CITY OF ALBUQUERQUE

November 19, 2021

RE: **Lot 3 Block 12 S.A.D. 227 Unit 5**
6508 Jade Dr. NW
Grading and Drainage Plan
Engineers Stamp Date 11/17/2021 (E10D113)

ENGINEER'S SEAL  11/17/21 DAVID SOULE P.E. #14522	LOT 3 BLK 12 UN 24 VC 6508 JADE DRIVE GRADING AND DRAINAGE PLAN  RIO GRANDE Engineering P.O. BOX 53924 ALBUQUERQUE, NM 87199 (505) 321-9099	DRAWN BY DEM DATE 11-16-21 6508 Jade Dr. DWG SHEET # C1 JOB #

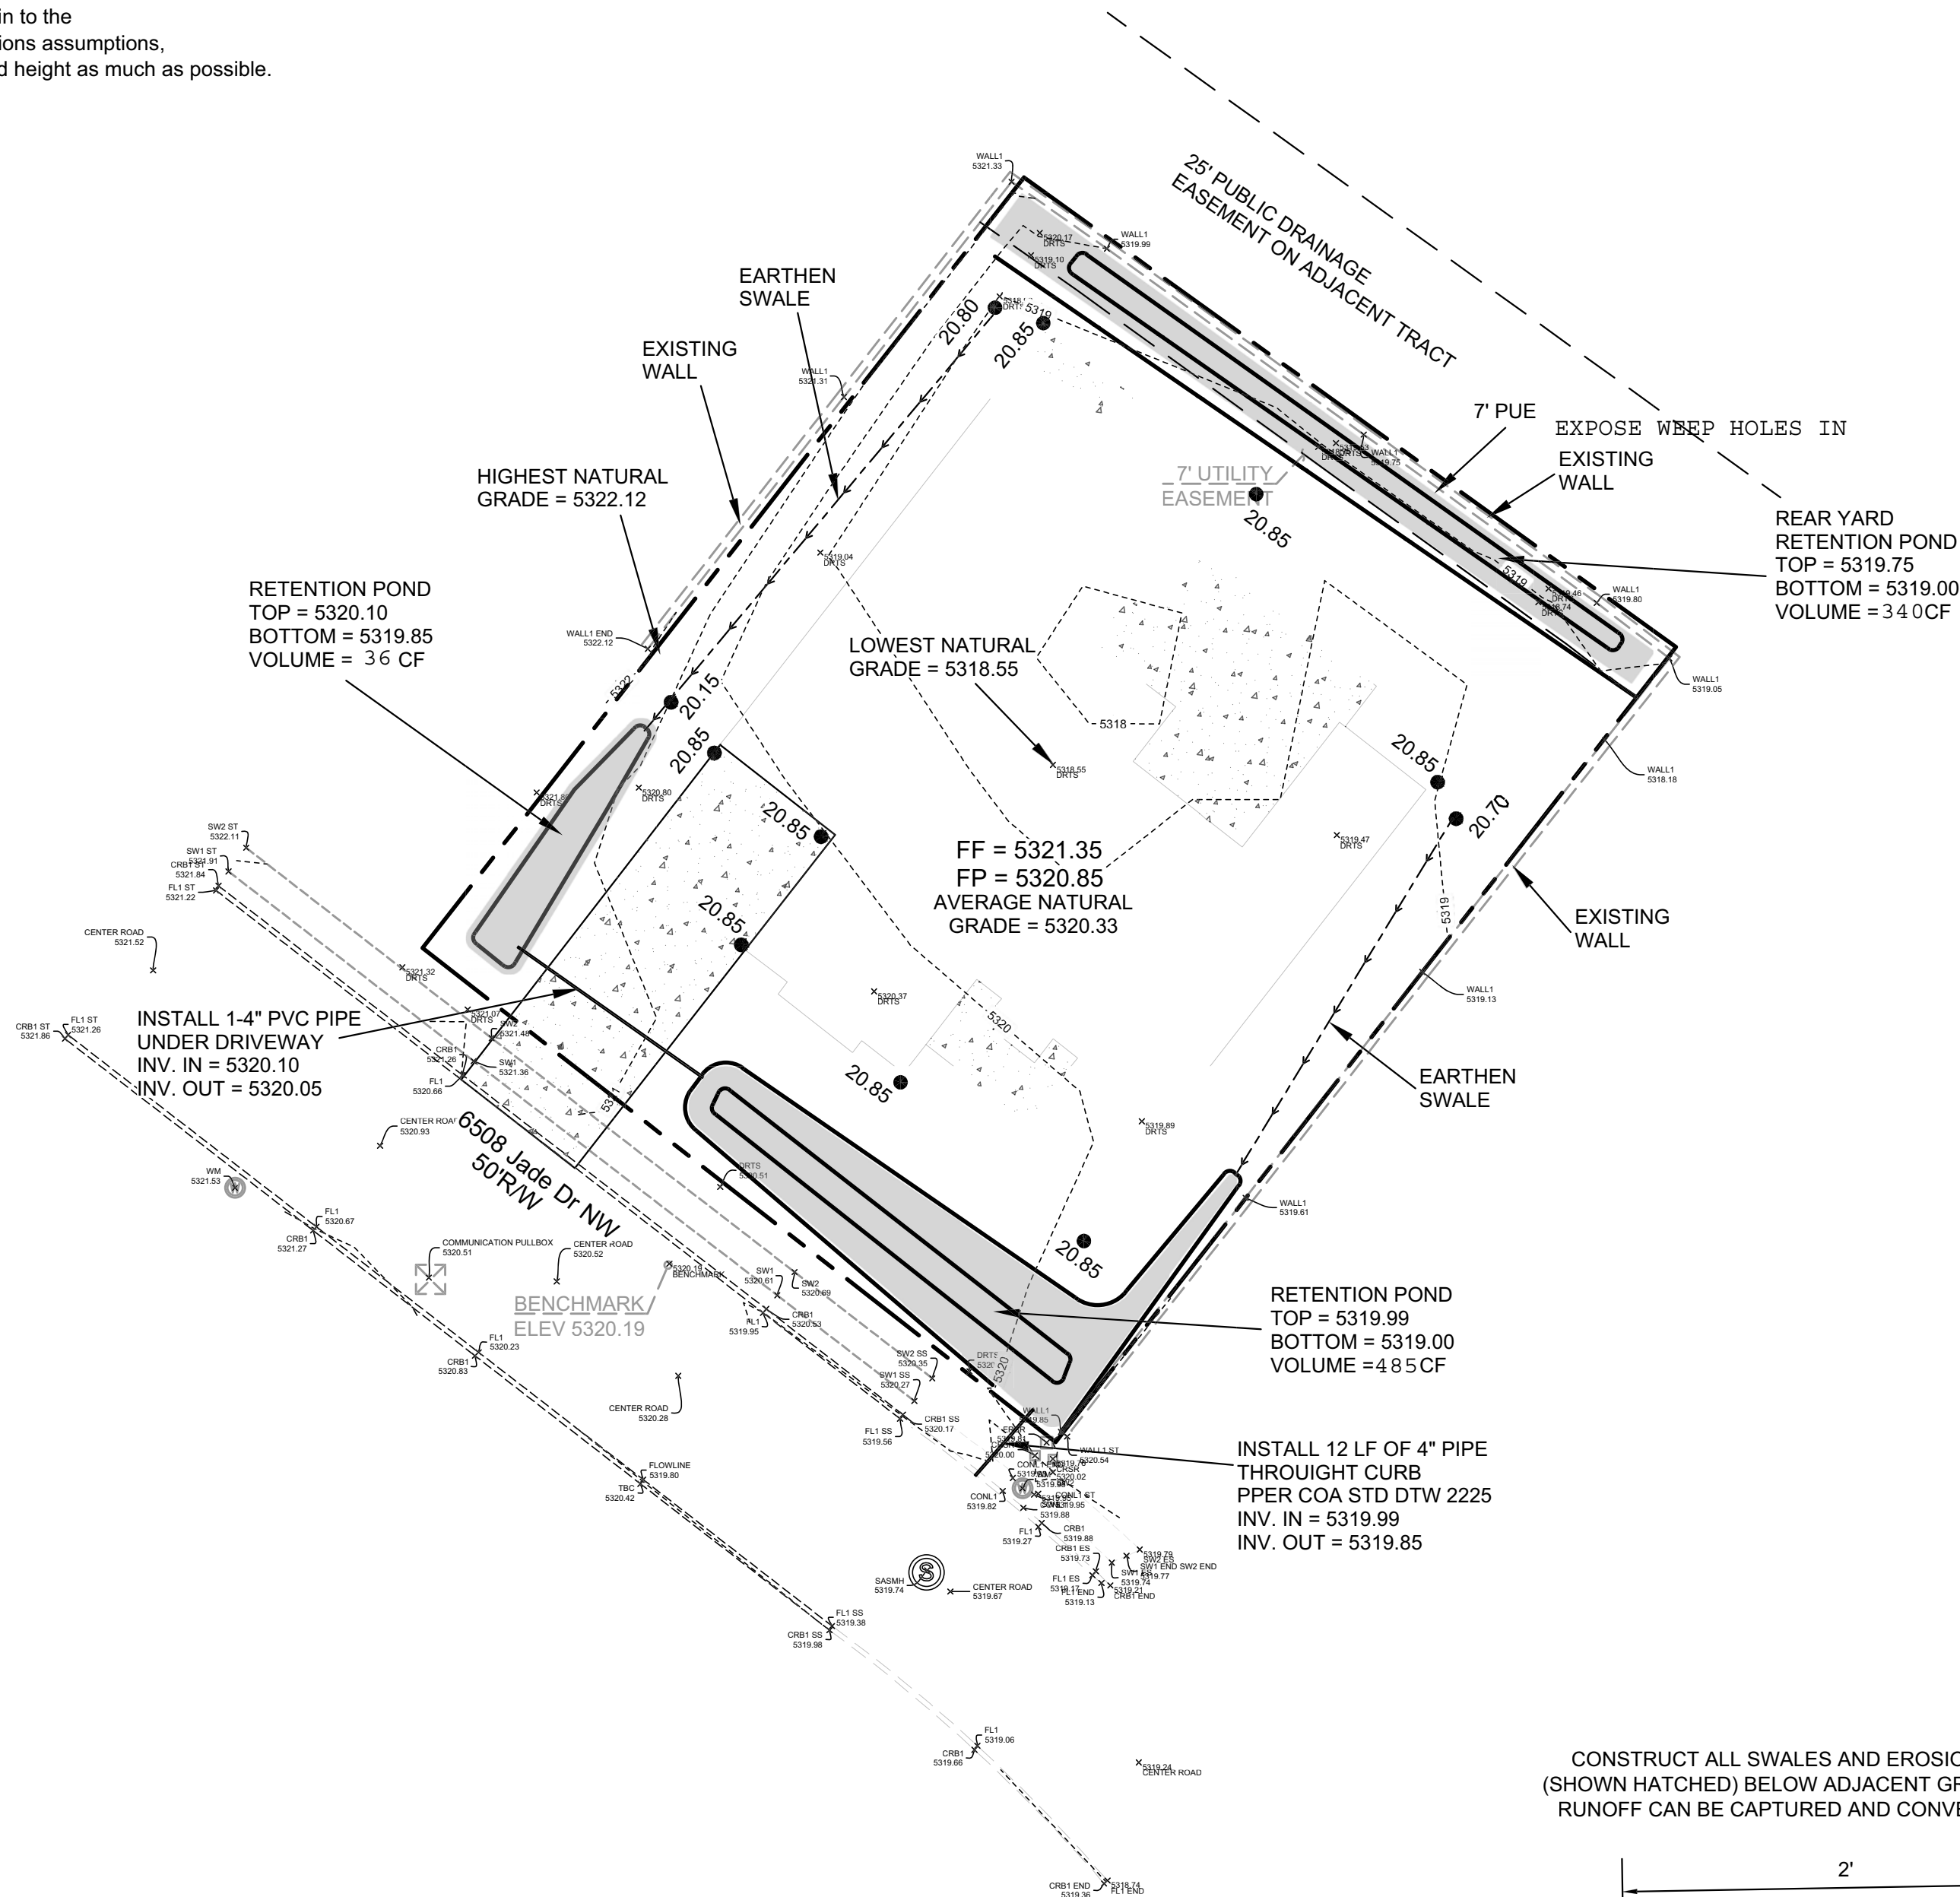
Based upon the information provided in your submittal received 11/18/2021, this plan is approved for Grading Permit. Please inform the builder/owner to attach a copy of this approved plan and letter into the construction sets in the permitting process prior to sign-off by Hydrology.

Reiterate to the Owner/Contractor that a separate permit for any garden/retaining wall must be obtained, with the approved G&D plan. Advise the owner contractor not to use dirt as a ramp to climb the curb, use lumber or crusher fines for this purpose.

Also, let the owner/contractor know that if a pool is to be added in the future the G&D plan will need to be modified showing the location of the pool and the land treatment differences.

Prior to Building Permit approval, a **Pad Certification** will be required. Inform the contractor/owner not to pile dirt in the street as a ramp to climb the curb. If dirt is found in the street the pad cert. will be denied.

Prior to **Certificate of Occupancy release**, Engineer Certification per the DPM checklist of this plan will be required.
